Access Compliance Report

Public Rights-of-Way

| Intersection ID: 52288 | Main Street: STEELE_CREEK_RD | Cross Street: DIXIE_RIVER_RD | Location: | N |
| ADA ID: C2DBF222BCA5 | Ramp Type: Para | Initial Pass/Fail: Fail | Overall Compliance: No | Severity Score: 12.5 |

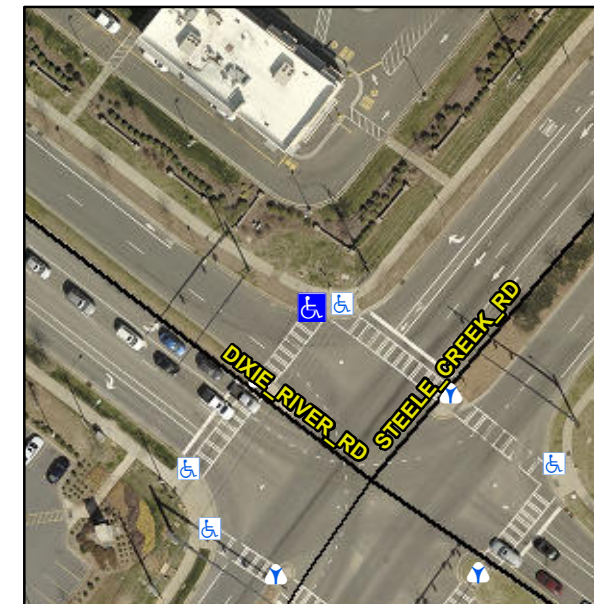
RT RP < 5%

R304.3.2

| Compliance | Description | Data | Compliance | Description | Data |
|------------|----------------------|-------|------------|-----------------------------|------|
| No | Ramp Slope LT (%) | 9.0 | Yes | Ramp Slope RT (%) | 4.0 |

Remove & Replace Entire Ramp.
